Planning Commission Meeting
Monday April 26, 2021
7:00 pm
Gardner City Hall
120 E. Main Street

1. **Willow Chase VI**
FP-20-03: Consider a final plat for 12 lots on 4.8 acres for Willow Chase VI

PROJECT NUMBER / TITLE: FP-21-03 / Willow Chase VI

REVISION	DATE	DESCRIPTION
1	DATE	DESCRIPTION 1
2		
3		
4		
5		
6		
7		
8		
DRAWN BY: ###		
CHECKED BY: ###		
DATE PREPARED: 3-16-2021		
PROJ. NUMBER: 21-023		
FINAL LANDSCAPE PLAN		
SHEET		
L1.0

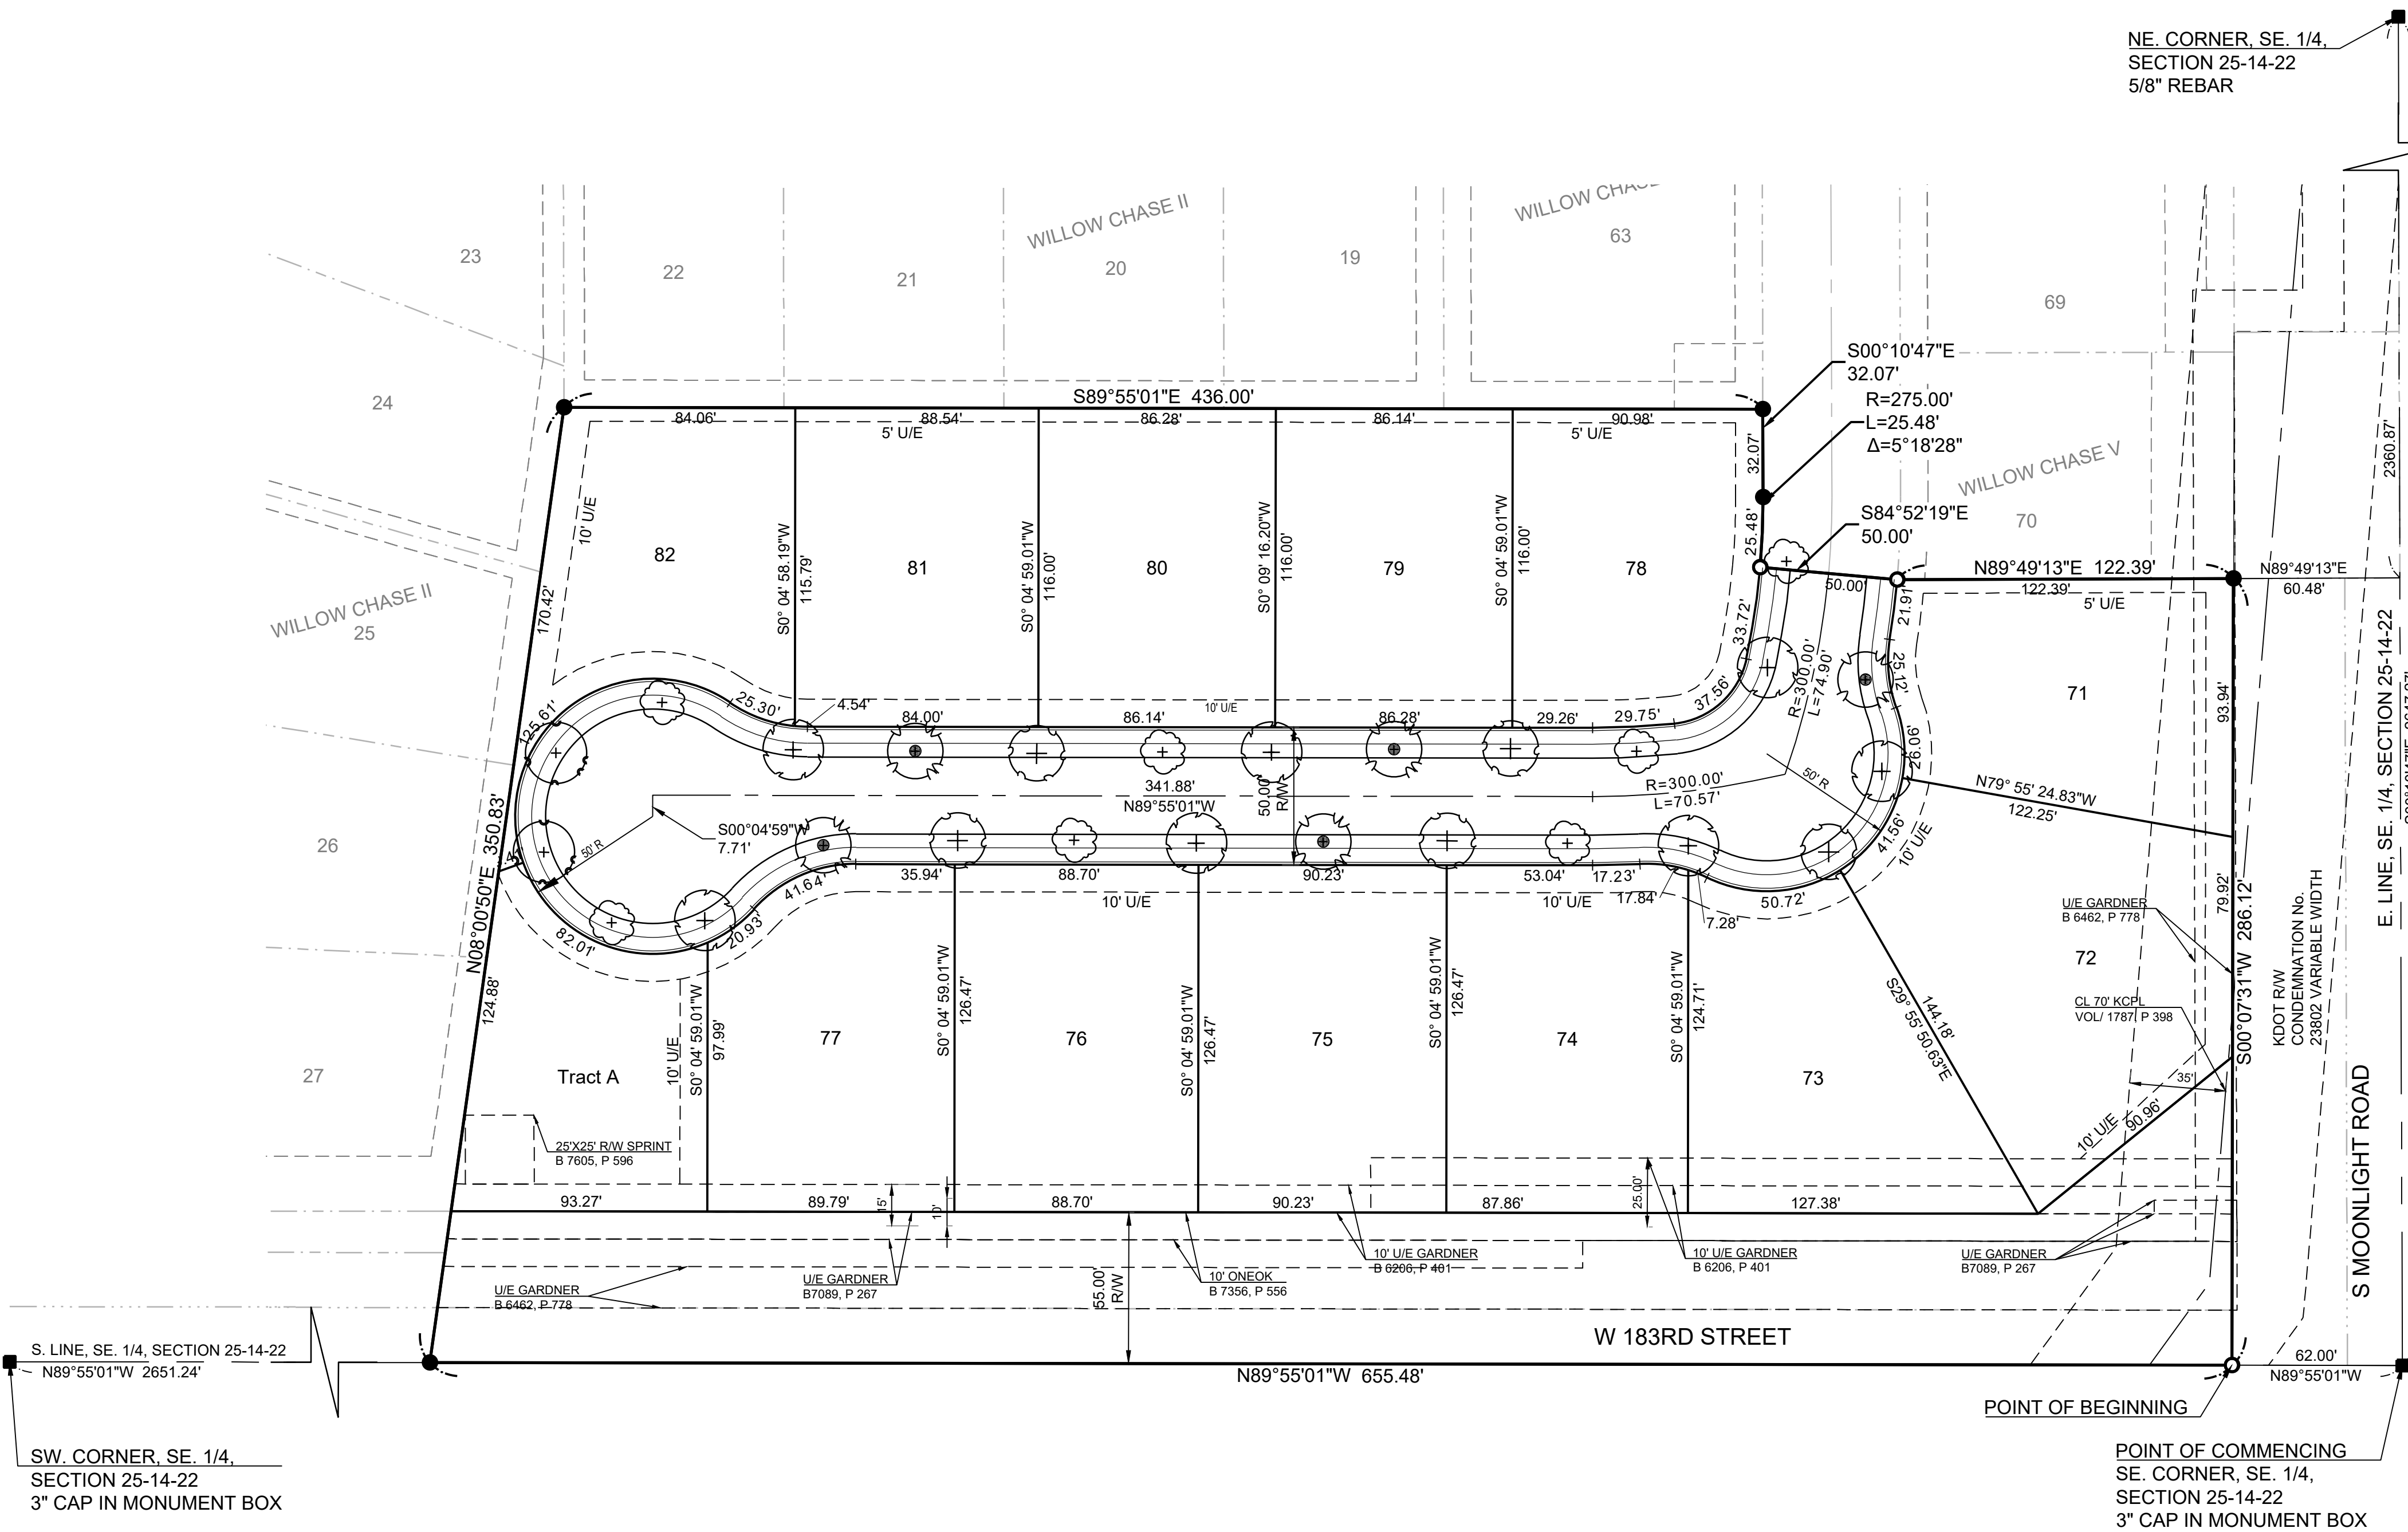
A street tree plan has been provided for review, showing street trees only at 40' – 60' on center along S. Hemlock Street, Dogwood Street, and S. Moonlight Road.

Staff Comment: *Staff has advised the applicant to meet the requirements for street trees per the LDC, which includes trees spaced 40' - 60' on center on the internal streets, it will need to be revised to include street trees along 183rd Street and Moonlight Road. This revision will be a condition of approval.*

1. Prior to the recording of the final plat, excise tax shall be paid to the City;
2. The construction plans for any utilities, infrastructure, or public facilities shall meet all technical specifications and public improvement plans shall be submitted and approved prior to the release of the plat for recording;
3. Constructing of a 10' wide trail on the north side 183rd Street and a 5' wide sidewalk along the west side of Moonlight Road;
4. Provide a revised street tree plan to include trees along Moonlight Road and 183rd Street;
5. Providing a note on the plat that describes the use and maintenance of Tract "A"; and
6. Labeling the cul-de-sac name.
